## **Planning Commission Staff Report**

**Project Type:** Sign Package

**Meeting Date:** October 9, 2017

**Description:** **500 Chesterfield Center (Midwest BankCentre) Sign Package:** A request for a Sign Package to establish sign criteria for the Midwest BankCentre for a 2.25 acre tract of land located southwest of the intersection of I-64/ US 40 and Clarkson Road, on the northeast quadrant of Chesterfield Center, and south of South Outer 40 Road (18S140365).

Figure 2: Proposed Over the Door Sign

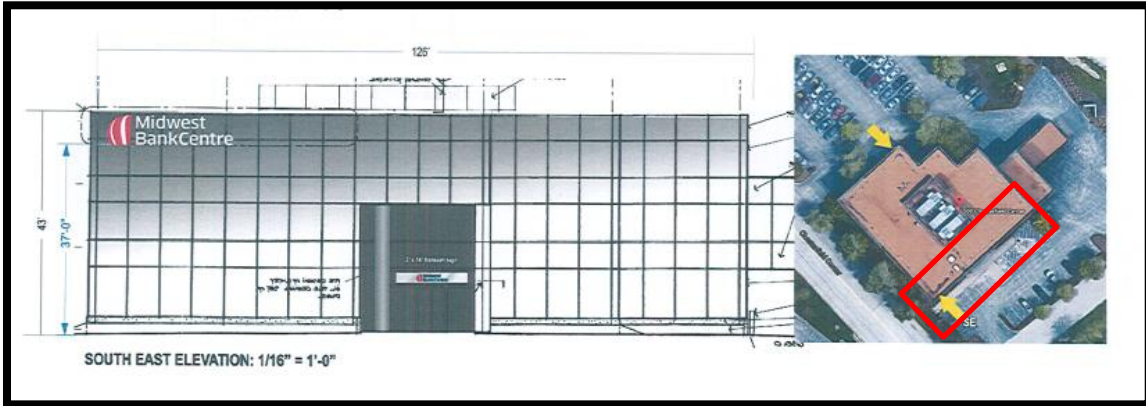
building. The signs do meet the UDC size criteria of 5% of the façade or less than 300 square feet. Additionally, the applicant is requesting an additional 28 square foot panel containing a 9.25 square foot over the door sign to identify the correct door which bank customers should enter.

Figure 5: Proposed monument sign (will utilize 'V' shape shown in Figure 4)

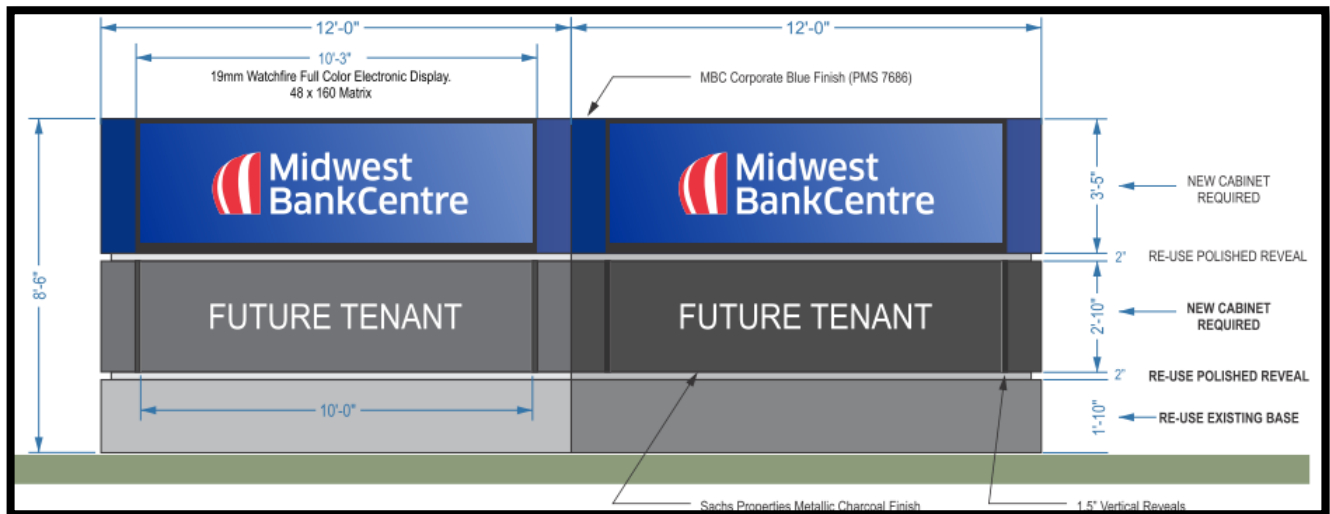
The UDC allows for businesses to have no more than one freestanding business sign facing each roadway on which the lot has frontage. This site has two frontages, along North Outer 40 Rd to the northeast and along Chesterfield Center to the southwest. The applicant is requesting that this two-sided sign remain as their only monument sign, and that the electronic message center be permitted to retrofit the existing sign. The applicant is wishing to replace all panels of the existing sign with LED screens to display “the Bank’s logo or static message to time and temperature” (from the applicant’s letter).

Electronic message centers are considered a prohibited sign under the UDC. Further, the UDC does not allow for signs to be illuminated by intermittent light sources, with the exception of “displaying time and temperature, stock market quotes or the manual changeable copy on a sign.” Additionally, while the sign was placed prior to the City’s incorporation, the UDC states that

nonconformities are not to be expanded, as they should be abolished or reduced to conformity as quickly as their fair interest to the parties will permit.

Since electronic message centers are prohibited signs in the UDC, the City has no regulations regarding brightness, frequency or speed in which the messages on these boards can change, and all of these factors may impact the safety and aesthetic quality along the corridor.
